TRANS/WP.29/GRE/2004/34 26 July 2004

PROPOSAL FOR DRAFT AMENDMENTS TO REGULATION No. 48

(Installation of lighting and light-signalling devices)

Transmitted by the expert from Japan

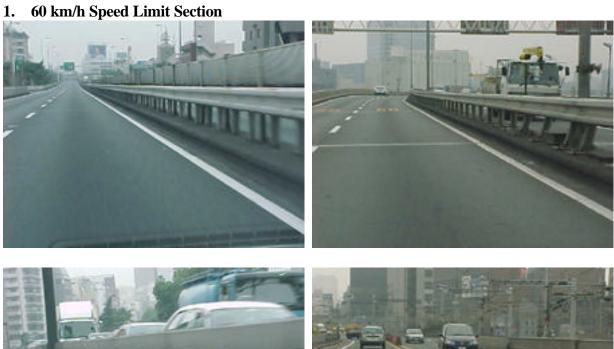
Moreover, as shown in the photographs below, in Japan some motorways are equipped with only low separation between the driving directions and lack antiglare fences. In other words, vehicles on these motorways are running in the same conditions as those on open roads. It should be avoided to use the class E mode of the passing beam that is less restricted about glare on oncoming traffic. This is the reason why Japan would also propose to amend the footnote $\underline{8}/$.

"8/ Traffic directions being separated by means of road construction, or, a corresponding lateral distance of opposing traffic is identified **in order to avoid undue glare from vehicles' headlamps in opposing traffic**."
